Hydrogeology of the Edwards and Trinity Aquifers in the Vicinity of the Proposed Vulcan Quarry, Comal County, Texas

Brian A. Smith, Ph. D., Texas P.G. #4955

Figure 8. Potentiometric surface map showing approximate Edwards groundwater flow direction in south-central Comal County to be to the southeast (Johnson et al., 2006).

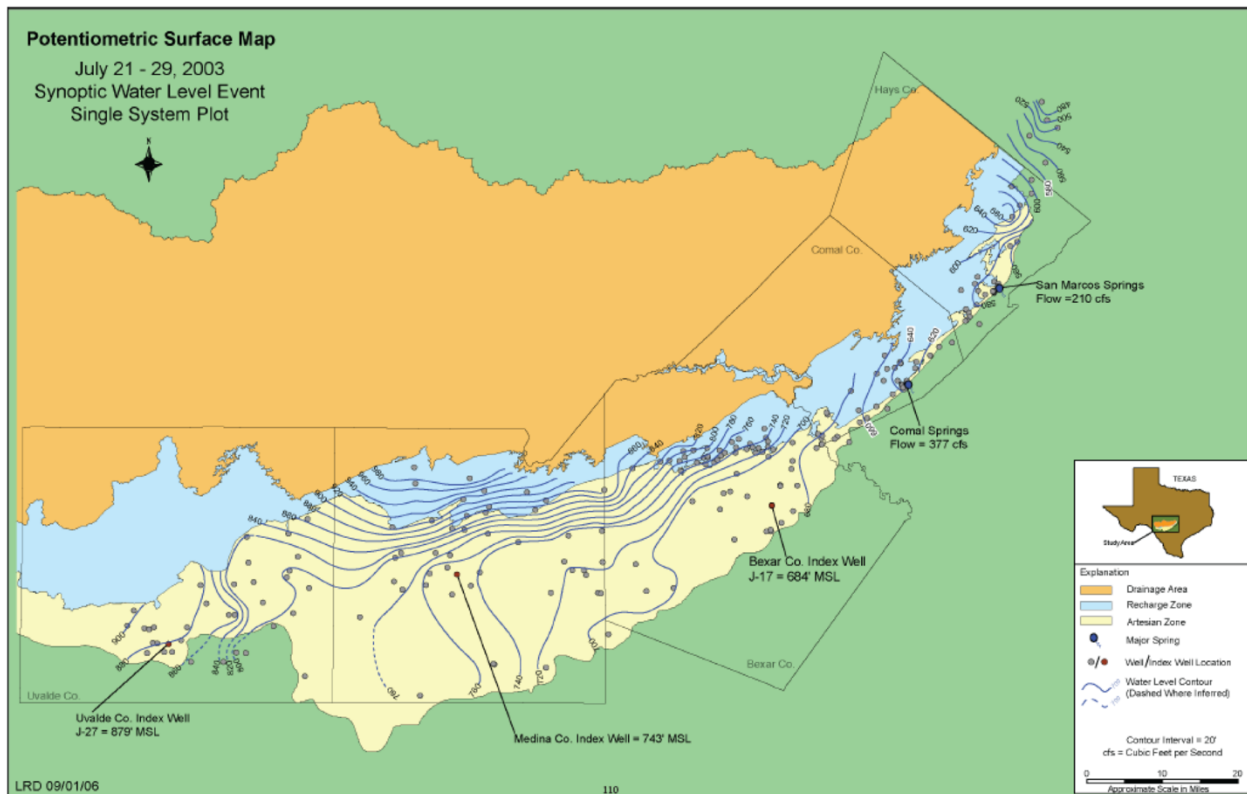
Figure 8 is a potentiometric surface map of the Edwards Aquifer with water-level data from 2003 (Johnson et al., 2006). Even though no data were collected close to the proposed quarry site, the map suggests that flow from the site would move generally southeast then shift to the east then northeast toward Hueco and Comal Springs. A study following a 2,000-gallon diesel fuel spill in January 2000 at the DynoNobel explosives plant near the CEMEX Balcones Quarry in New Braunfels, Texas, shows flowpaths of the diesel fuel to both Hueco and Comal Springs (G. Schindel, personal communication, April 12, 2024). The proposed Vulcan quarry site is located seven miles NW from the plant. Groundwater flowing from the site would flow generally southeast until it reaches these flowpaths and would ultimately discharge to Hueco and Comal Springs. Some lesser components of the flow would bypass the springs and flow further downgradient towards San Marcos Springs.

Figure 9. Schematic cross section with estimated topography after mining and water levels based on available data (J. Finneran, personal communication, April 16, 2024).

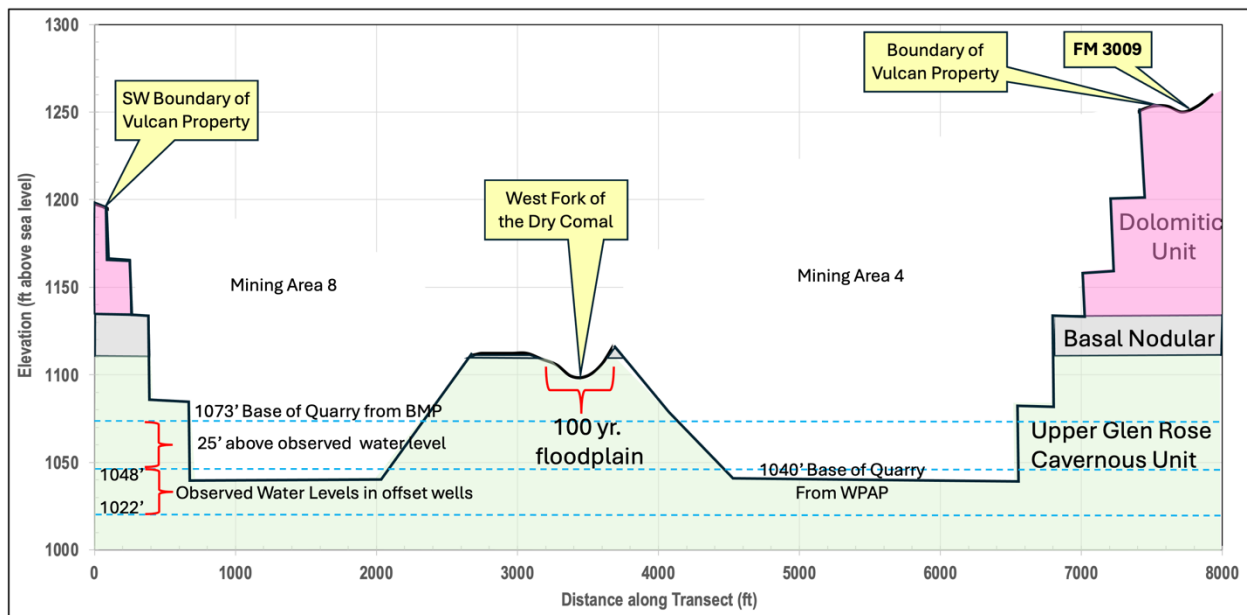
TCEQ requires that quarrying operations limit the downward expansion of a quarry to a level that is 25 ft above the highest expected water level (TCEQ, 2012). This level would either be set for water levels in December 2007, if available, or during a period equivalent to 90% of high rainfall. Because of limited water-level data on and near the site, it is difficult to determine what that level would be in the aquifer beneath different parts of the quarry site under varying rainfall conditions. To adequately evaluate water levels in the aquifer, the applicant should be required to do a thorough evaluation of data that are available and to collect data from onsite and nearby wells. A listing of wells and limited water-level data are included in Appendix A of this report (J. Doyle, personal communication, April 10, 2024). Because a water table is rarely a flat surface, a number of wells need to be measured within a short time period. These data then need to be compared to data collected during different wet and dry periods to determine appropriate water levels on all sides of the property. Water-level data from Hays (Hunt and Smith, 2019) and Bexar Counties (Johnson and Schindel, 2006), indicate that in the portions of the Edwards Aquifer at some distances from the major springs, hydraulic gradients can be as much as 100 ft per mile. Such a high gradient could be present beneath the quarry site, but it should be anticipated that there could be at least a 50-ft difference in water levels from one side of the site to the other. This difference in water levels would significantly impact the depth to which the quarry could be mined.

The WPAP (Pape-Dawson Engineers, 2024) for the site states that the mining areas will not be mined below an elevation of 1040 ft msl. According to the WPAP, this level of the quarry bottom will provide a 25-ft buffer above the high water level of the aquifer. A review of available water-level data indicates that at times, the bottom of the quarry will be flooded by the underlying aquifer (Figure 9). Water-level data from five wells close to the perimeter of the quarry boundary were evaluated to estimate expected water levels beneath the quarry and proposed depths of the excavations (Appendix B) (J. Finneran, personal communication, April 16, 2024). The White #4 well (#520690) had a water level of 1022 ft-msl on 12/5/07. At this water level plus the 25-ft buffer, the bottom of the quarry would be out of compliance. Another well (Tucker, EAA #Wxxx-137) had a water level of 1048 ft on 12/14/98. At this water level, the bottom of the quarry would be 8 ft below the water level in the aquifer.

- Elevations of the aquifer should be determined prior to any excavation. The elevation of 1040 ft-msl for the bottom of the quarry, as stated in the WPAP, is likely to be out of compliance with the required buffer of 25 ft. And it is also likely that water levels in the aquifer will be above the elevation of 1040 ft-msl during periods of high water levels.
